CHATSWOOD TO SYDENHAM
**SYDENHAM STATION
AND SYDNEY METRO
TRAINS FACILITY SOUTH
MODIFICATION
SUBMISSIONS REPORT**

Purpose of this report

During public exhibition of the modification report, 15 submissions were received by the Department of Planning and Environment. The Secretary of Department of Planning and Environment provided copies of the submissions to Transport for NSW.

Figure 7 PMF flood level - existing

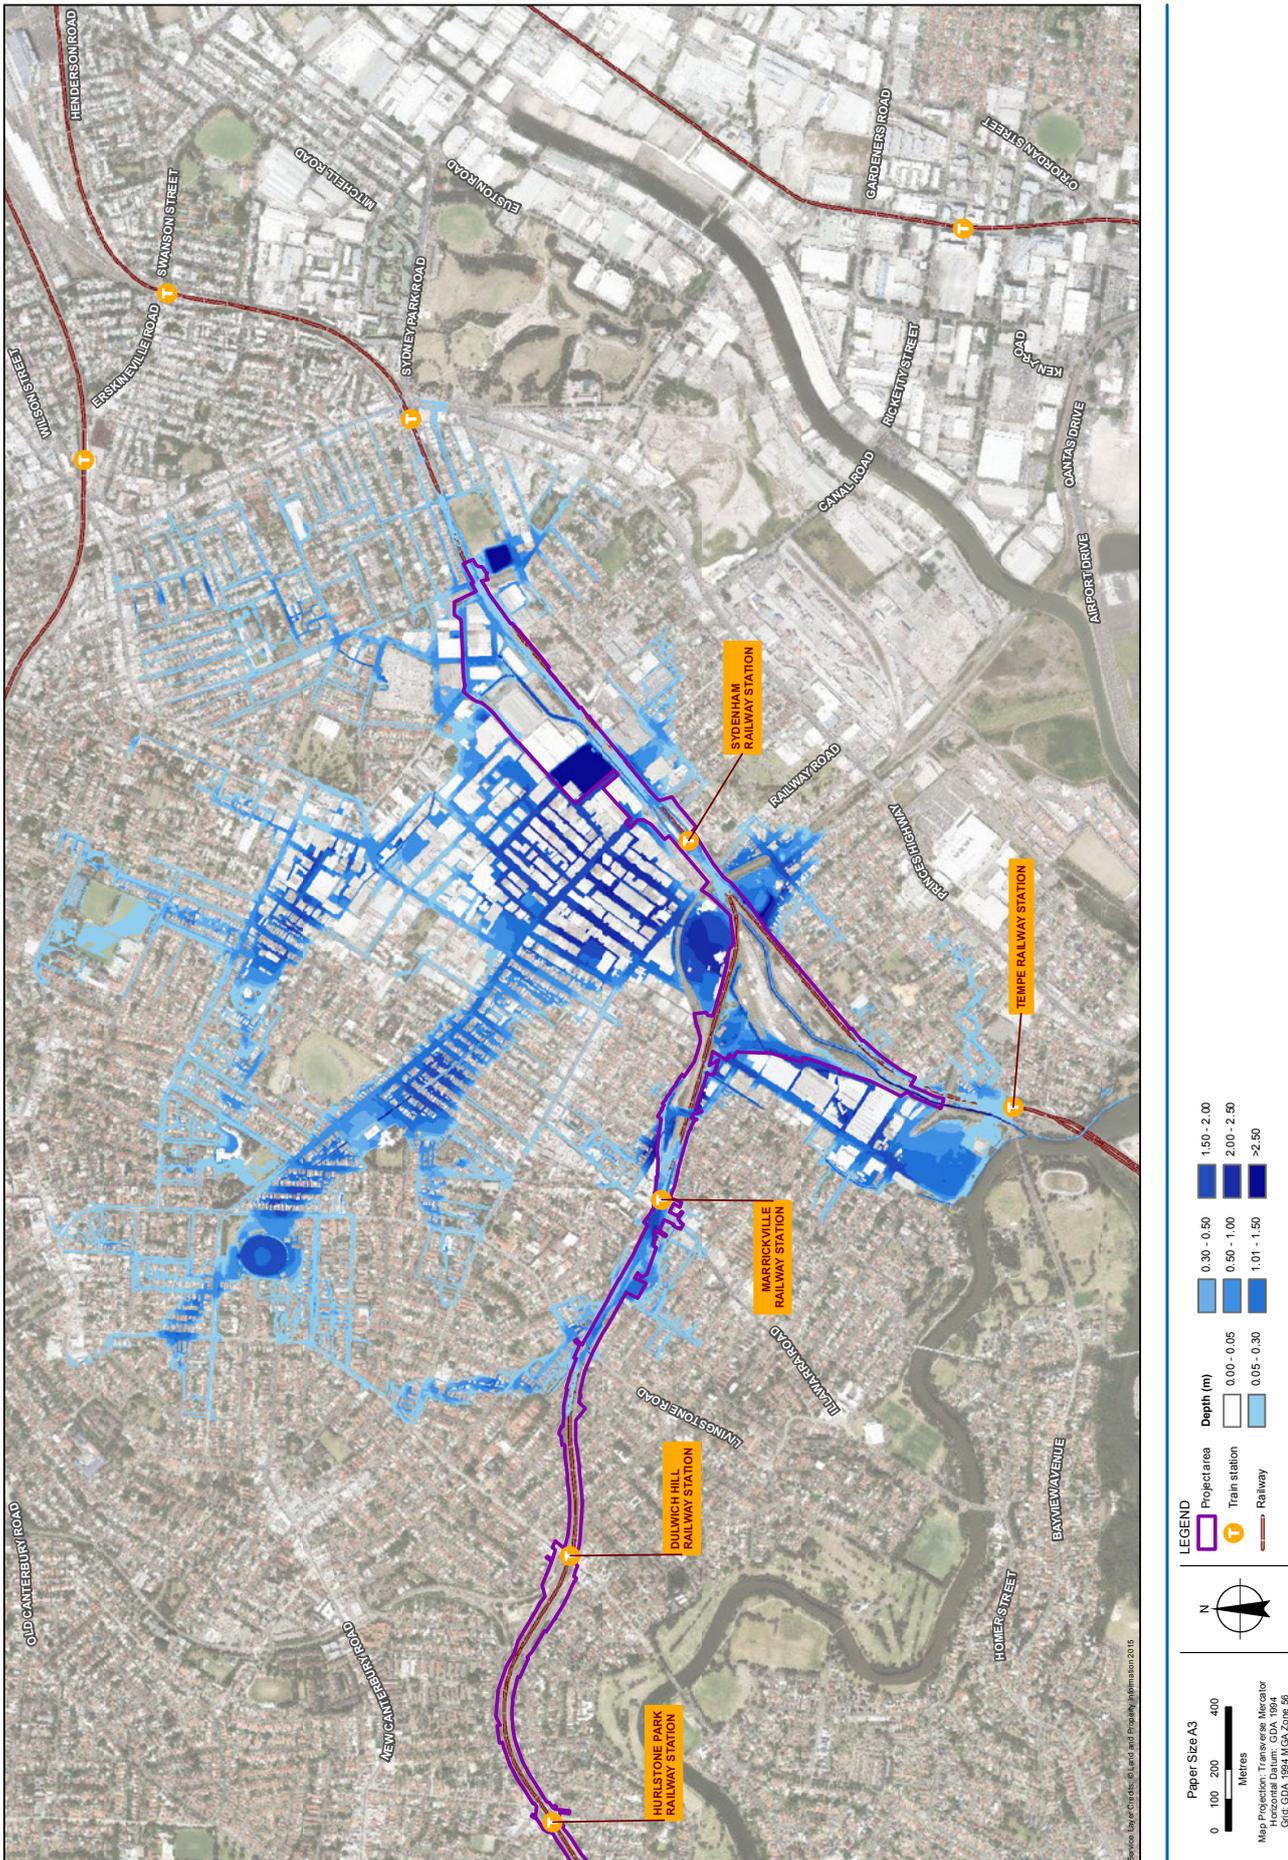
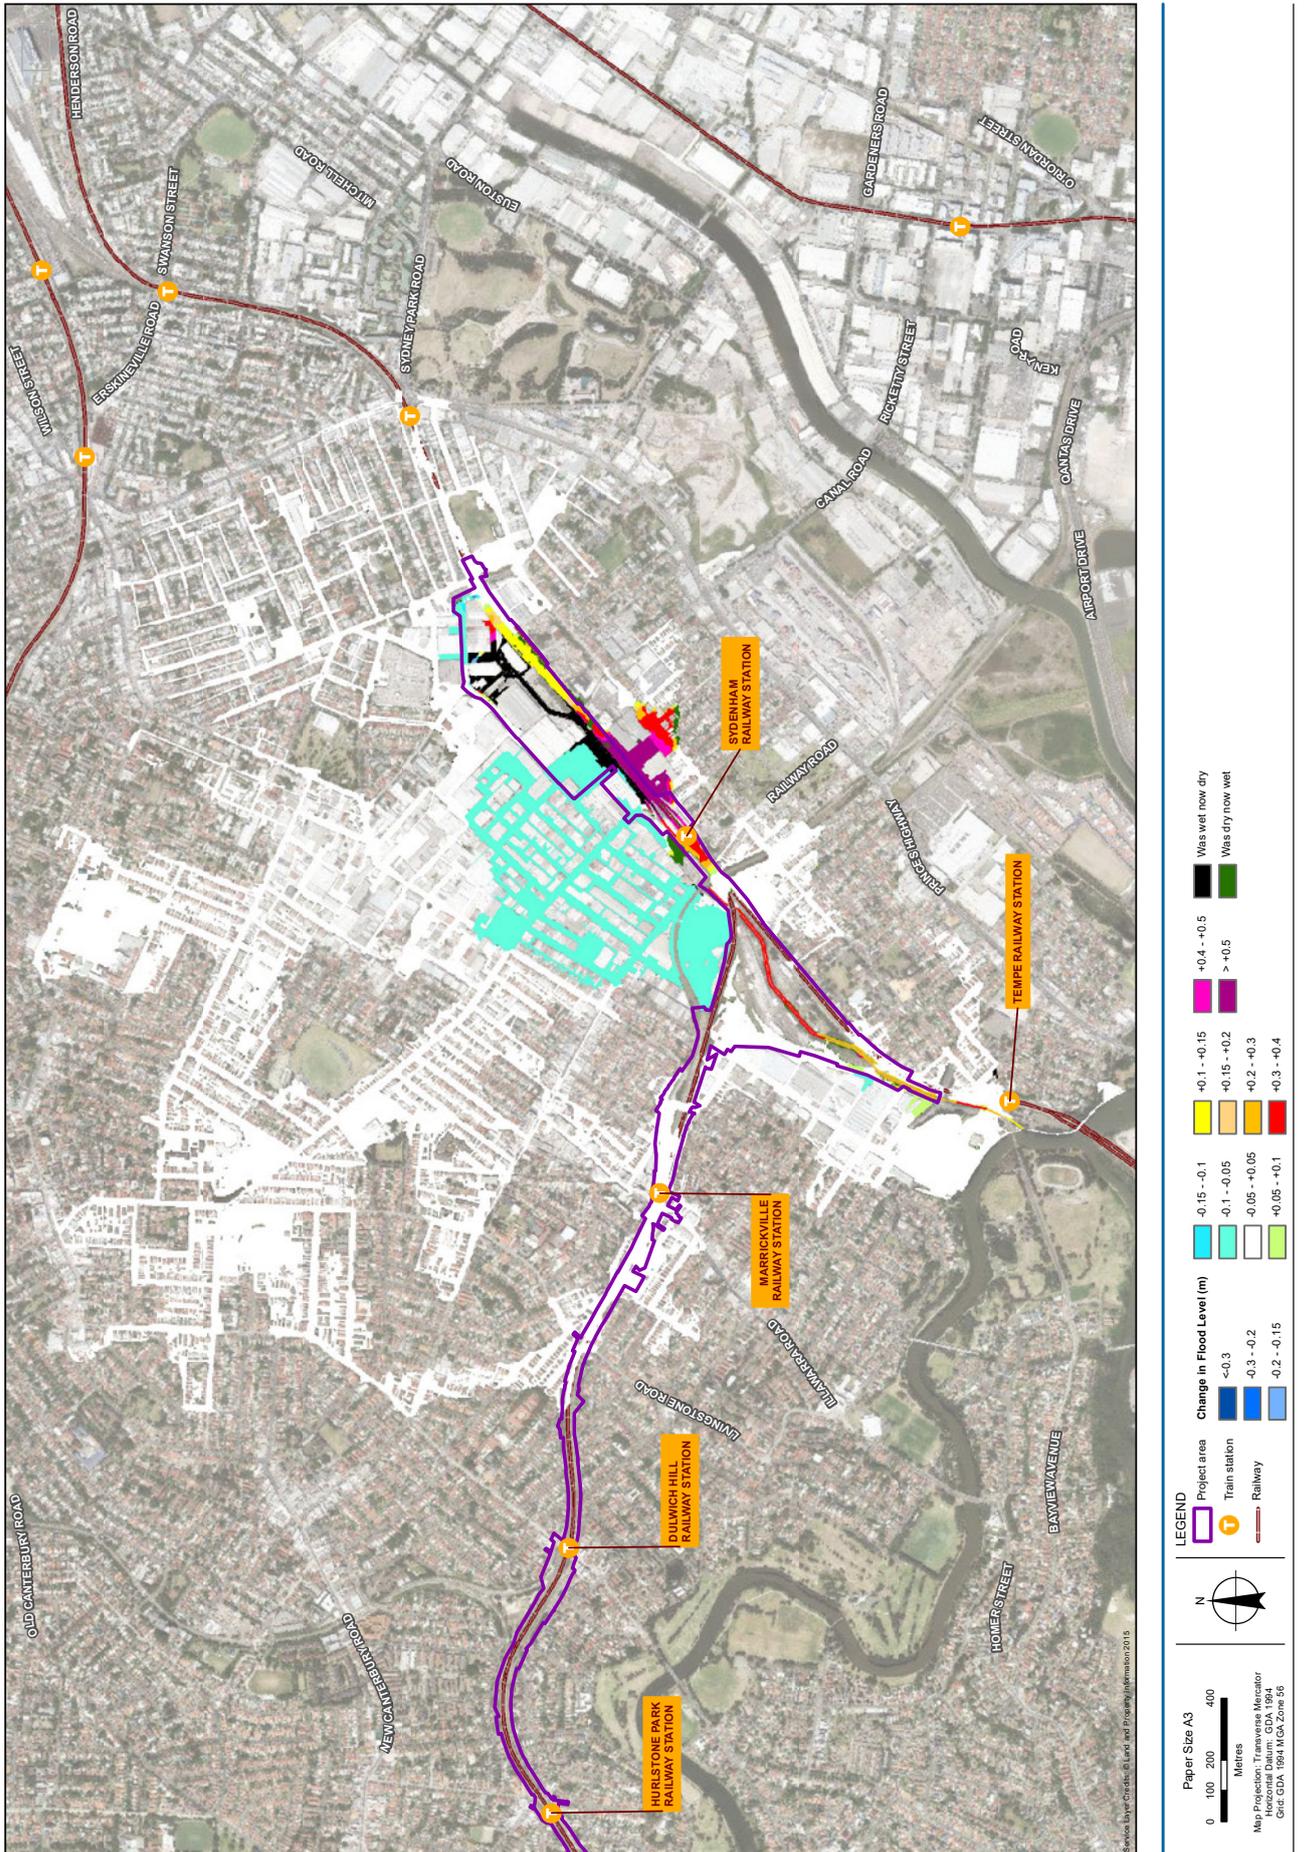
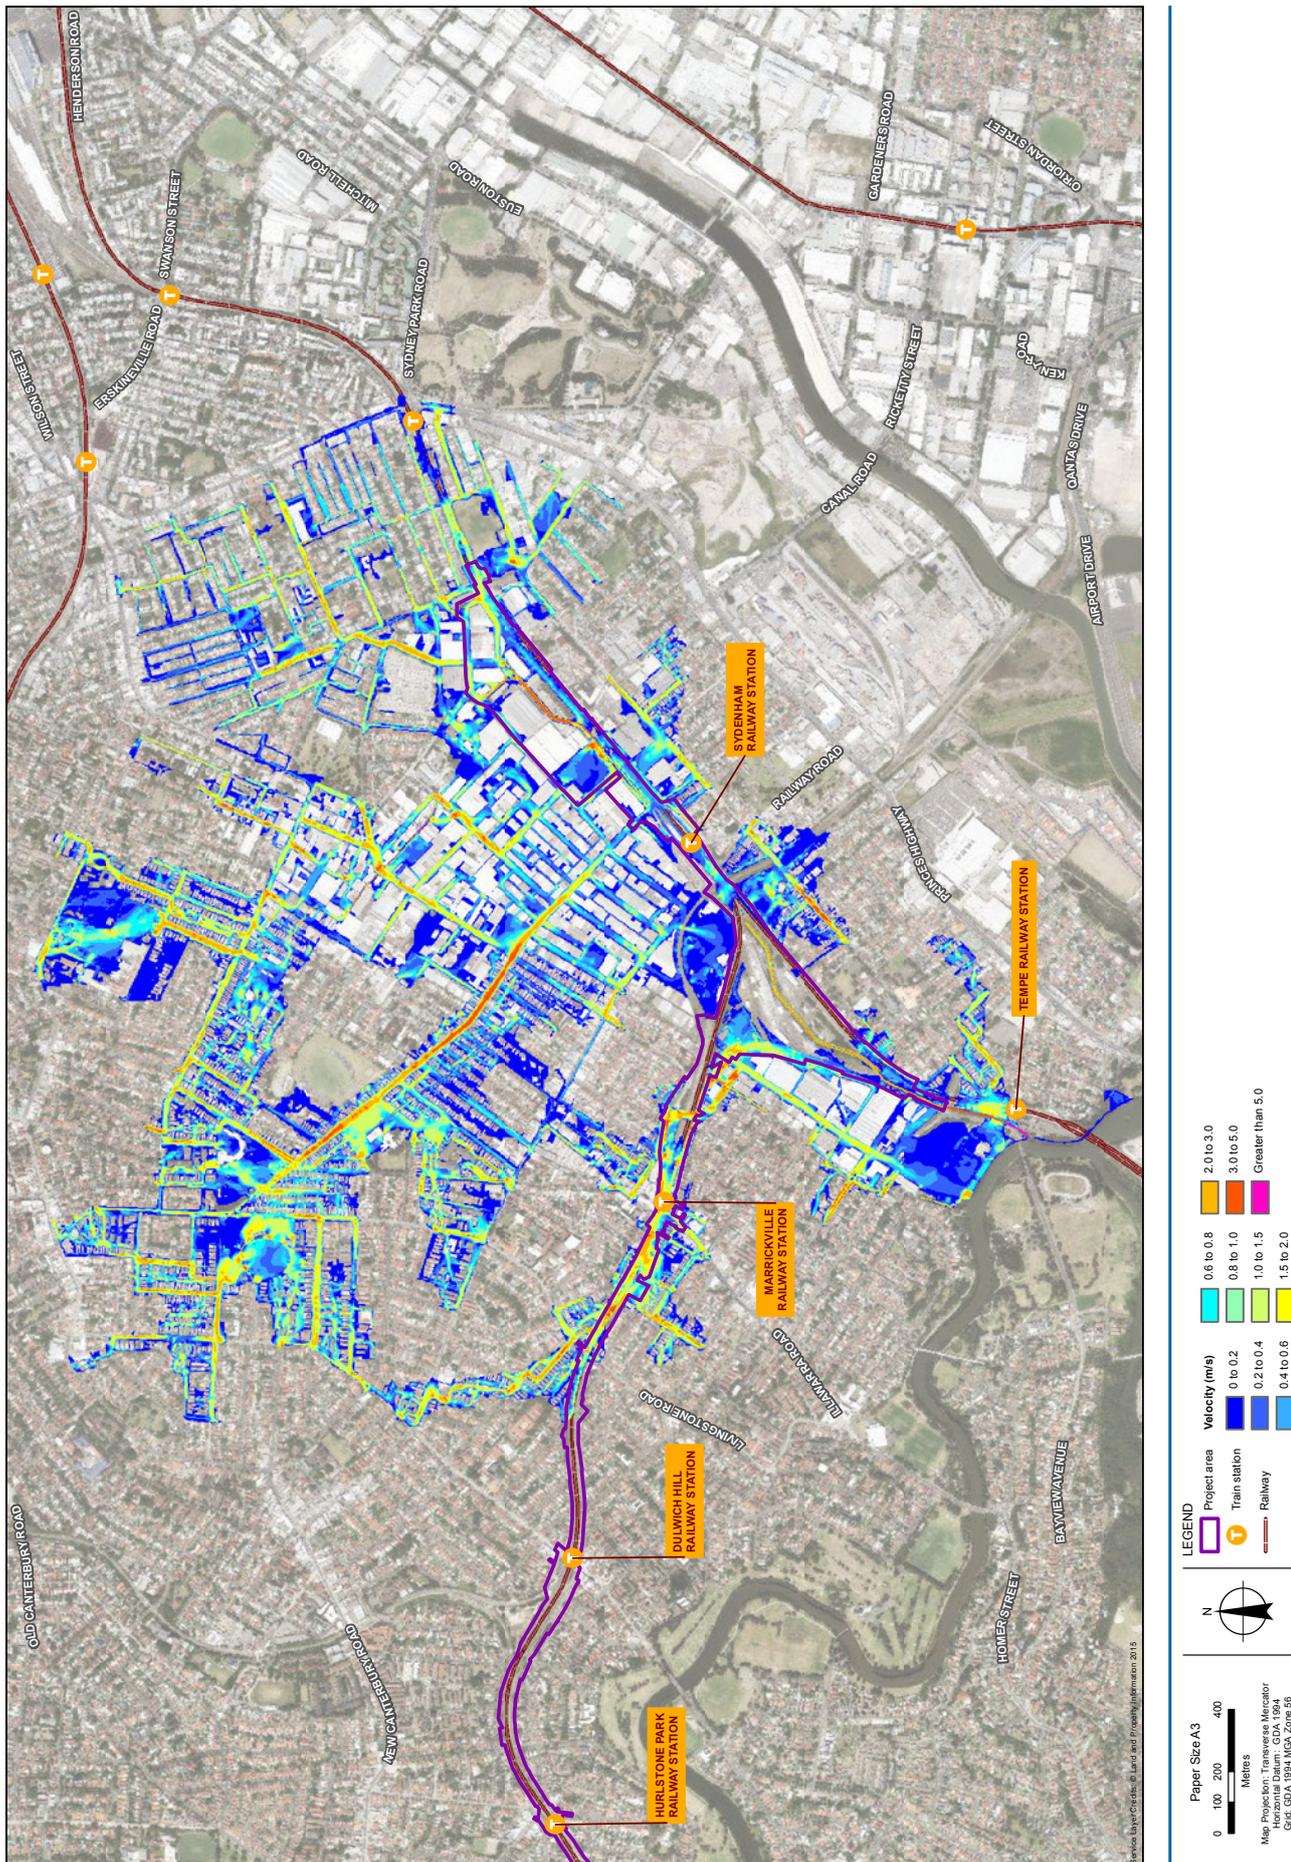
The modification report indicates that the modification will result in increases in flood depth and extent in the vicinity of Frederick and Sutherland streets. From a floodplain risk management perspective, it is prudent that the proponent adequately investigates the following:

- Identify additional properties that would be affected by over floor flooding in 1 per cent annual exceedance probability, which in existing conditions are subject to ground flooding only
- Identify additional properties that would be within the flood planning area, which are currently above the flood planning level
- Identify additional properties that would become flood affected due to the increase in the probable maximum flood extent
- Identify the potential for increase in flood damage due to the above points
- Address impacts on emergency management planning
- Undertake a consultation process with affected property owners and Inner West Council.

The modification report identifies that, with the proposed drainage and flood improvements in place, flooding impacts with the proposed modification would generally be less than those identified for the approved project. Notwithstanding, there is predicted to be an increase in flood depths in some locations, including on Sutherland and Fredrick streets. Additional technical information relating to the flooding assessment is provided in Appendix C.

- The one per cent AEP plus 10 per cent flood level change
- The one per cent AEP plus 10 per cent velocity change
- The one per cent AEP plus 10 per cent provisional flood hazard
- The PMF flood level change (as was provided in the modification report)
- The PMF velocity change
- The PMF provisional flood hazard.

This additional mapping does not change the outcomes of the flooding assessment provided in the modification report. Additionally the mitigation measures, which provide a performance standard for the project, would continue to apply.
